DATE:	ISSUE / REVISIONS:
06.18.2013	Site Plan Submittal
09.17.2013	Response to Staff Comments
10.29.2013	10/18 Staff Response
11.14.2014	Resp. 2.12.14 Staff Comments
2.10.15	Per Certification Comments
04.21.2017	Settlement Modification
07.19.2018	Arch. Elevation Revisions
08.06.2019	Class II Modification 2019

BLDG III ELEVATIONS

A3.4

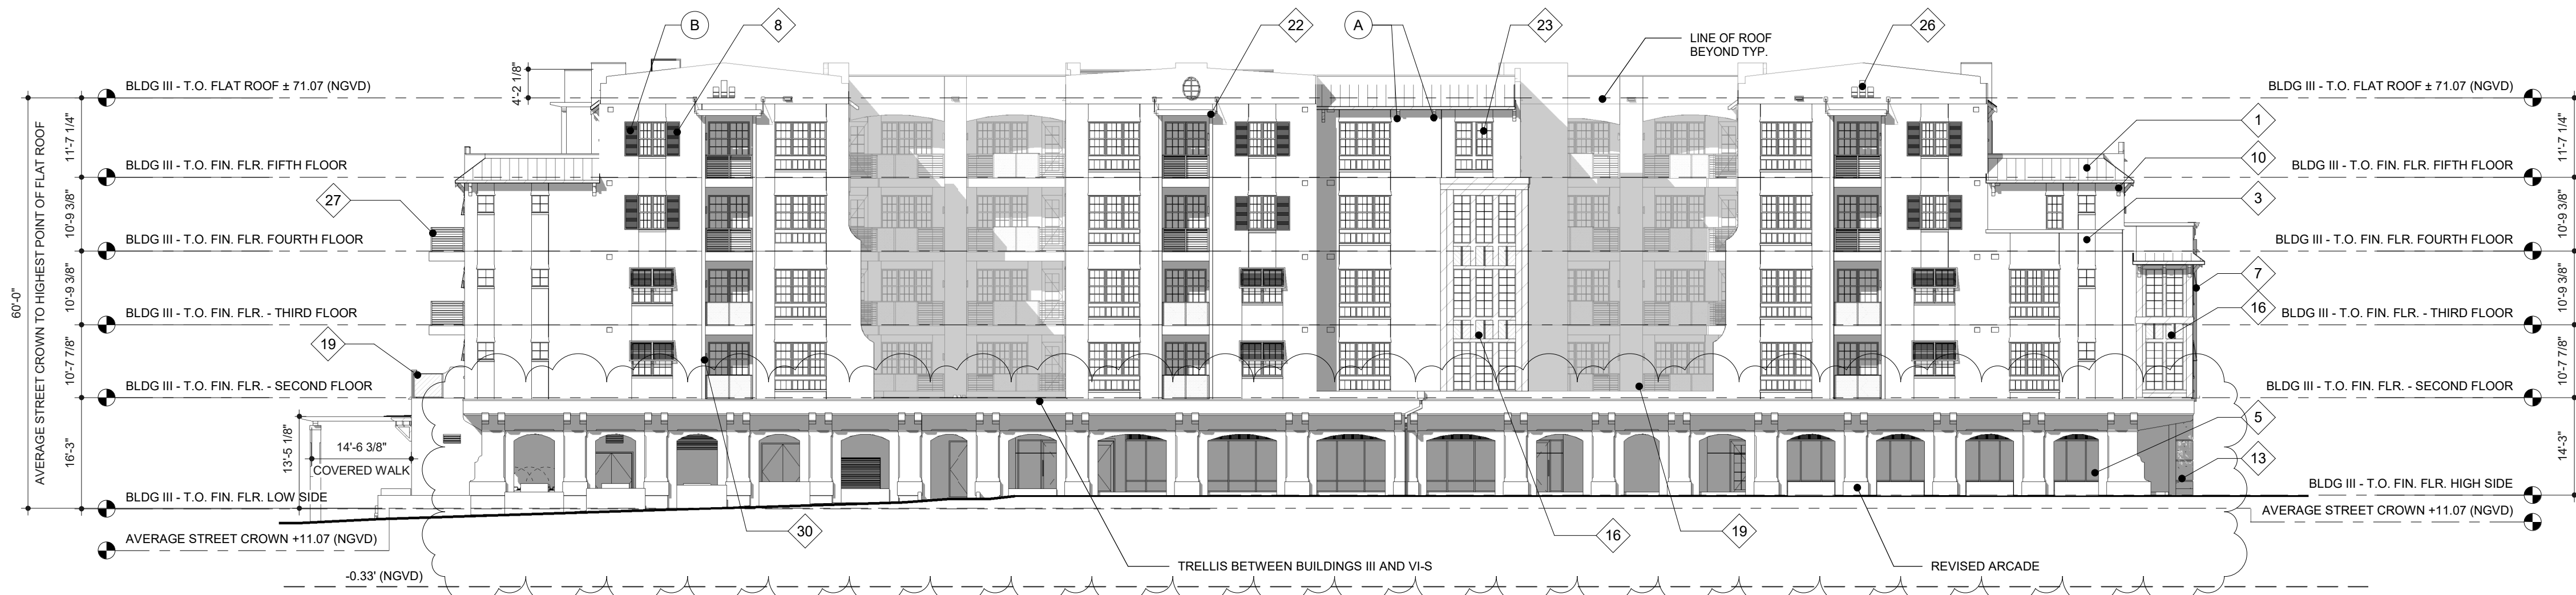
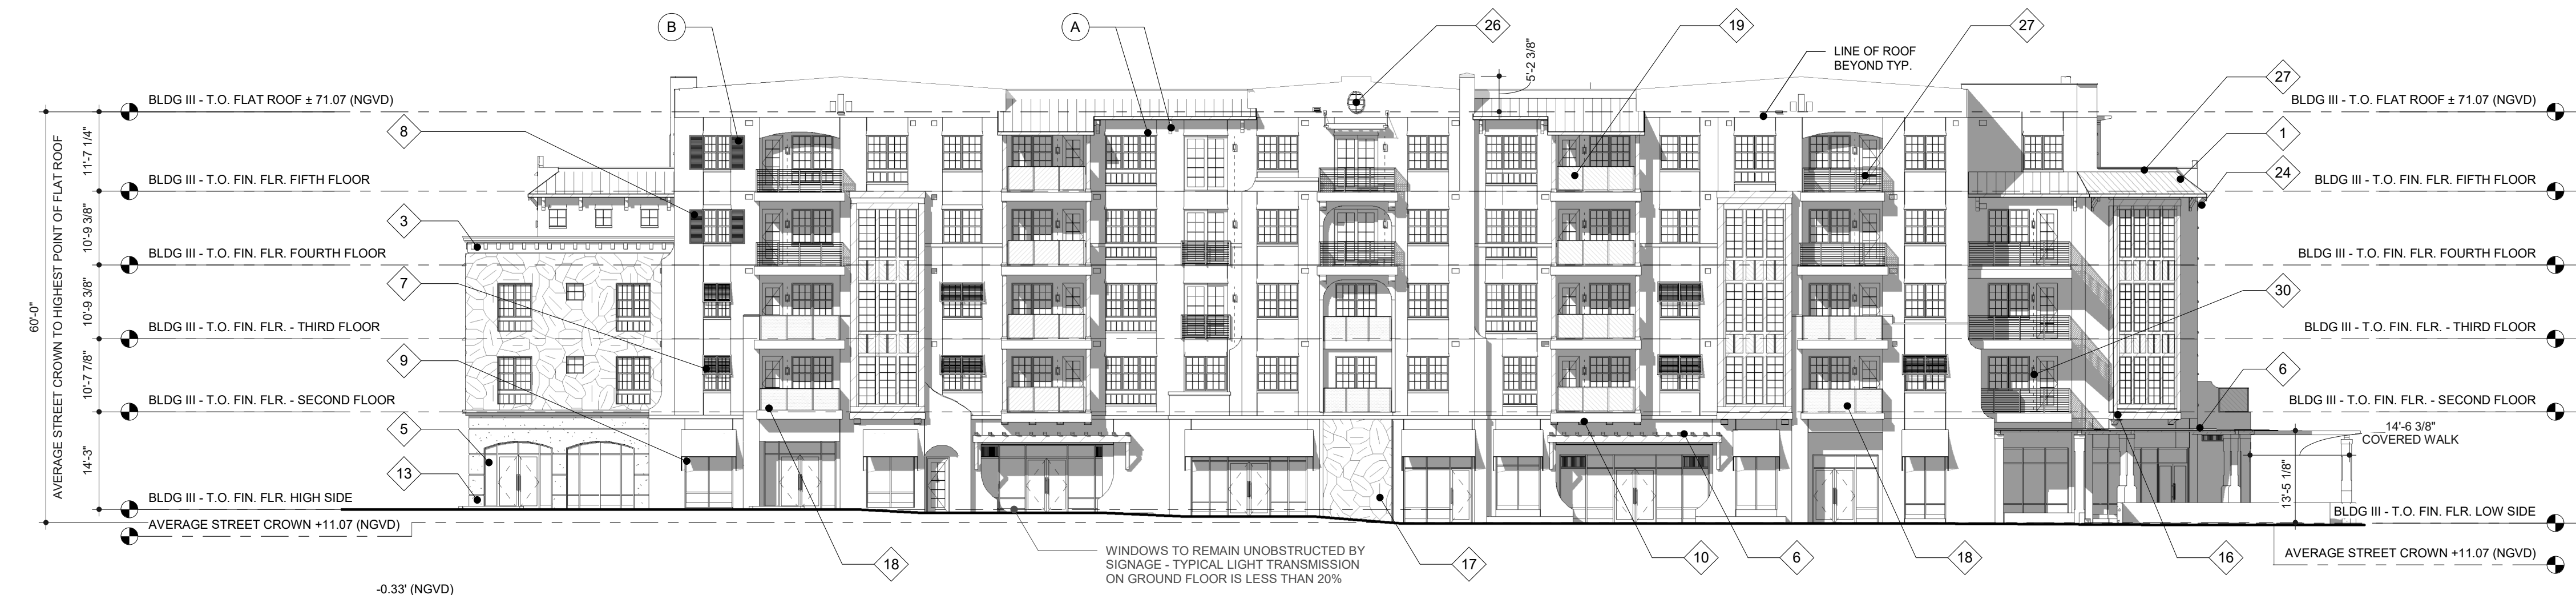
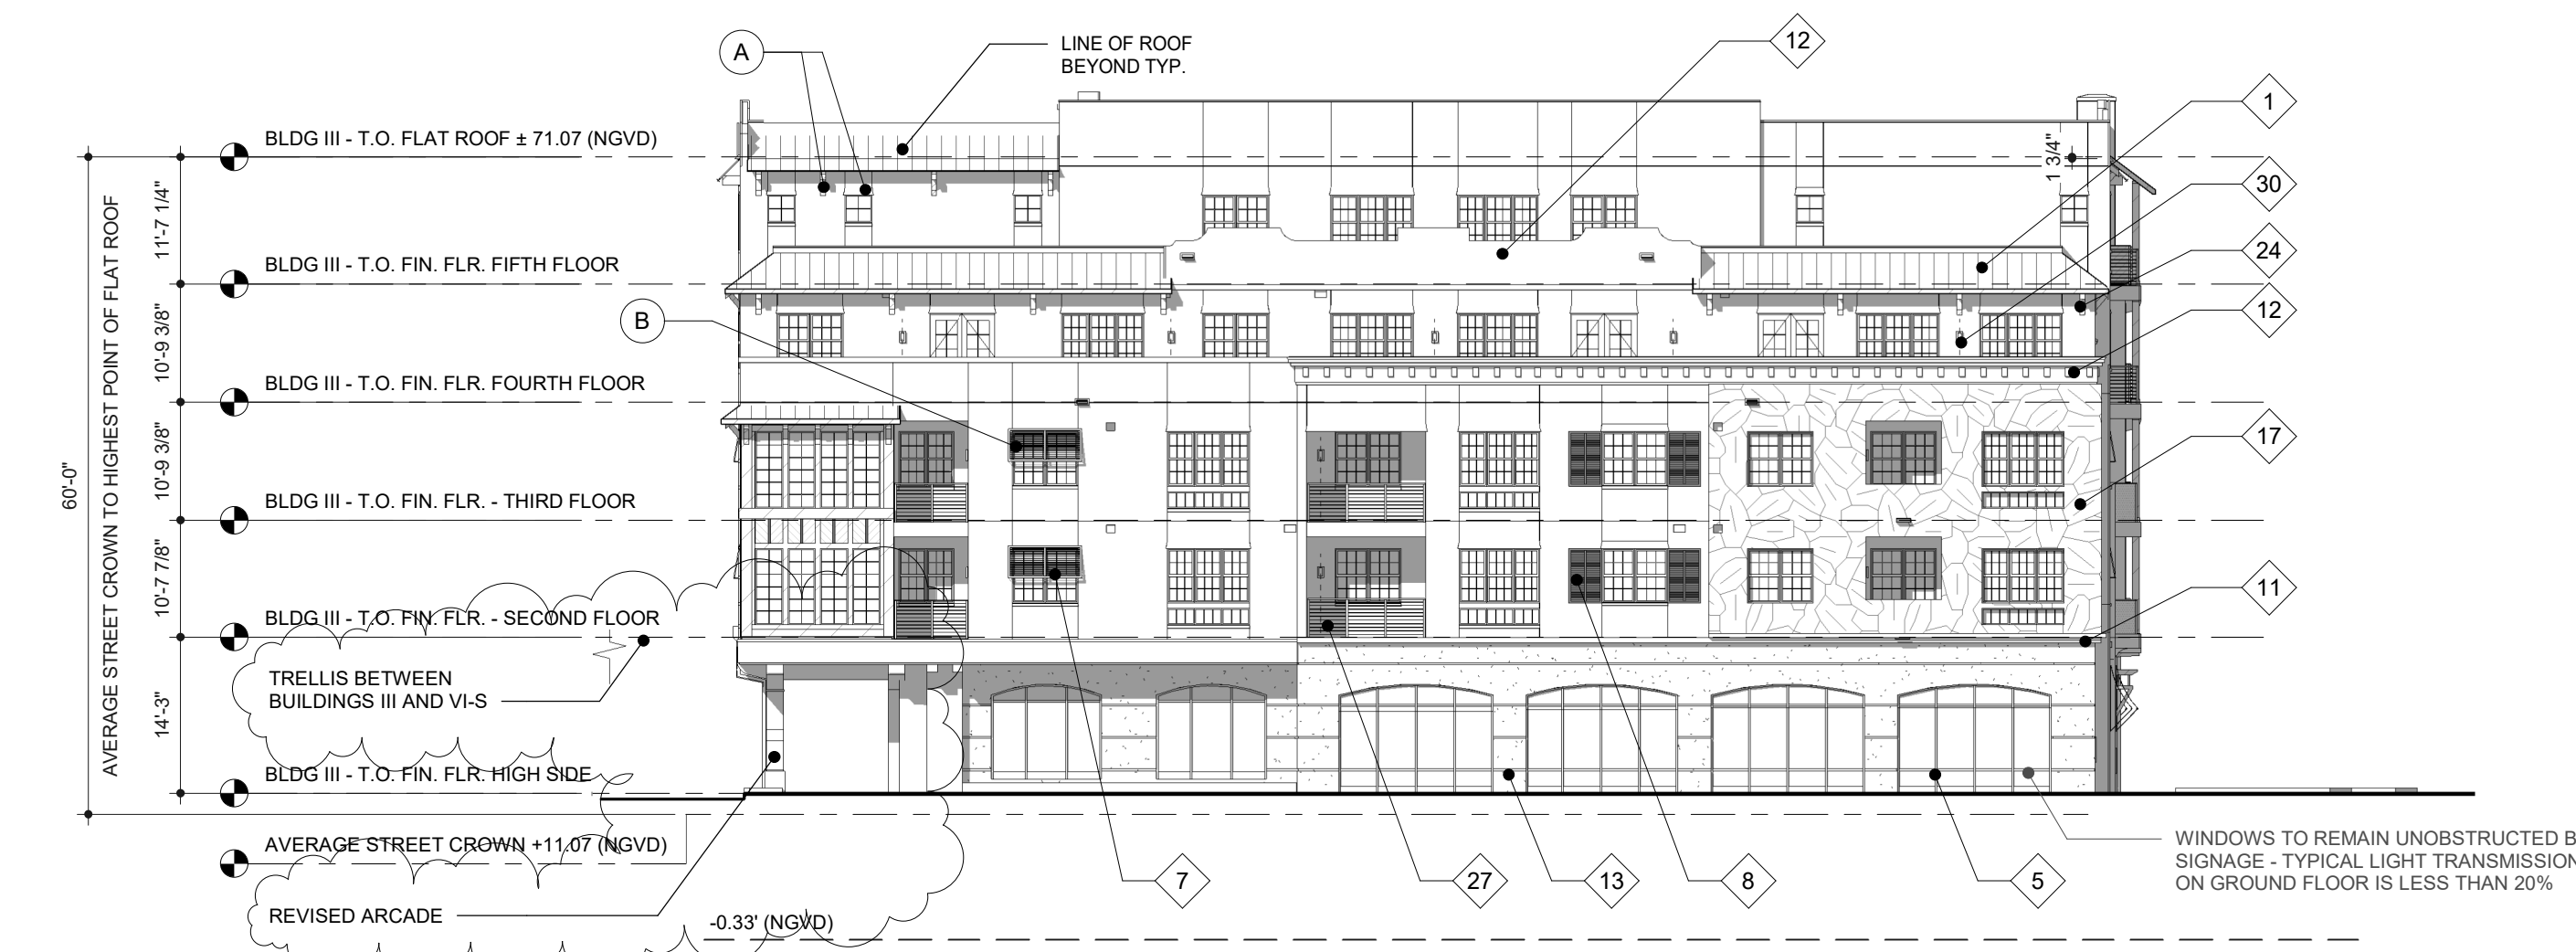
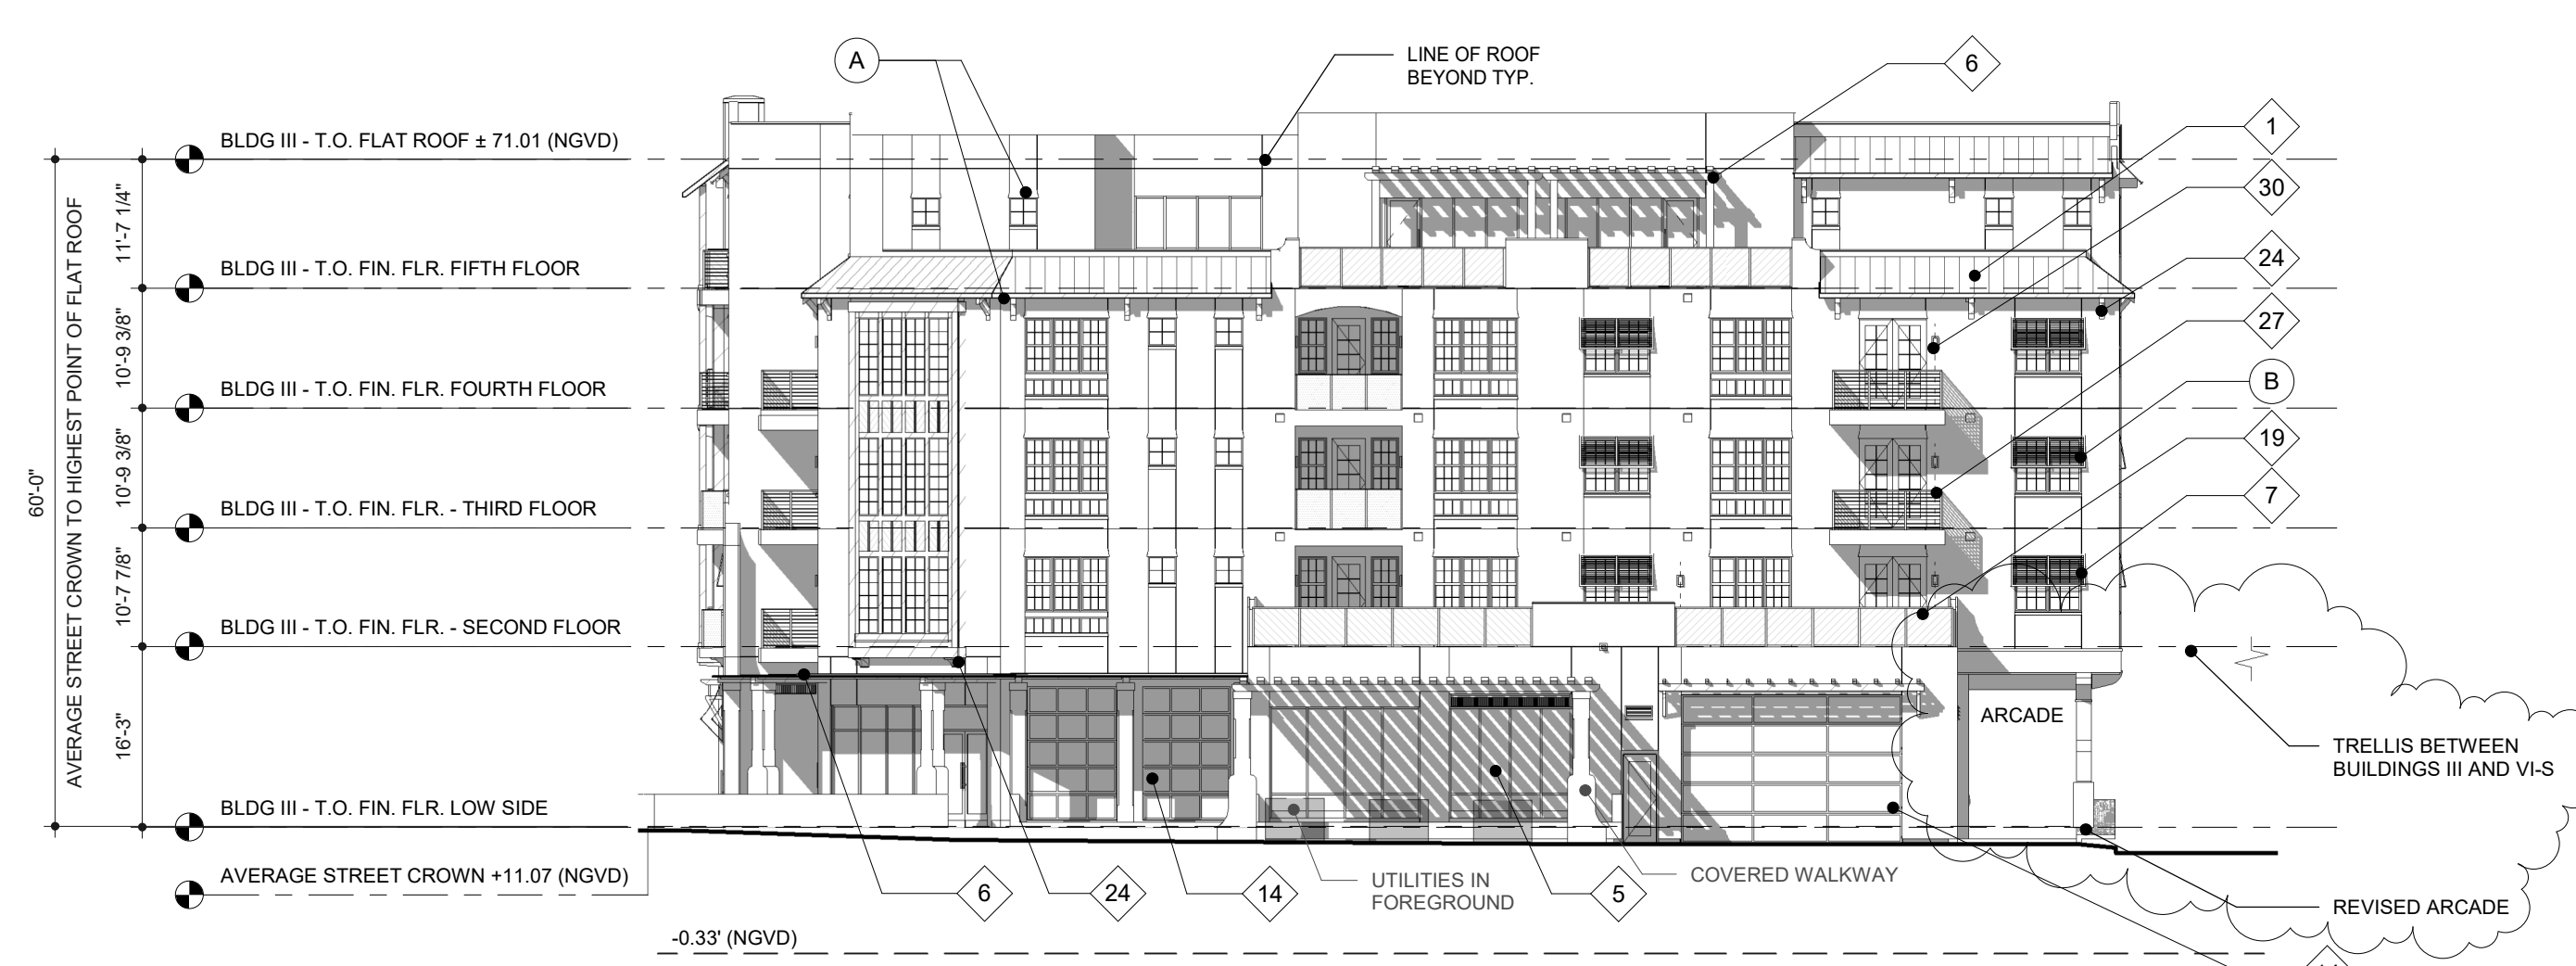
- BUILDING III NORTHWEST FOOTPRINT ADJUSTED DUE TO ADDITION OF RAMP AT NE 6TH AVENUE
- WINDOWS OF THE BUSINESSES AND OFFICES REMAIN UNOBSTRUCTED BY SIGNAGE
- LIGHT TRANSMISSION FOR GROUND FLOOR GLASS AREA TO BE NO GREATER THAN 20%
- KNOX BOXES TO BE PROVIDED AT ROLL DOWN GATES
- GREEN WALL IS CONSIDERED A TRELLIS WHICH SHALL BE ALLOWED TO ENCOACH INTO SETBACK ALONG FEDERAL HIGHWAY
- ADDED INGRESS/EGRESS RAMP AT NE 6TH AVE

- ADD ARCADE ALONG THE NORTH ELEVATION
- ADJUST POSITION OF LOADING AREA
- ADJUST EAST AND WEST ELEVATIONS DUE TO ADDITION OF ARCADE.

- SCULPTED FORMS AT ARCADE AND AT FEATURE ELEMENTS OF THE BUILDING
- RE-SCALE WINDOWS AT CORNERS
- WOOD DETAILING AS ACCENT AT VERTICAL FORMS
- ENWANCE DETAIL AT BUILDING CAP
- RE-DETAIL ARCADE AND LOW ROOF FORMS

- REVISE DETAIL AT ARCADE
- ADD TRELLIS BETWEEN III & VI-S
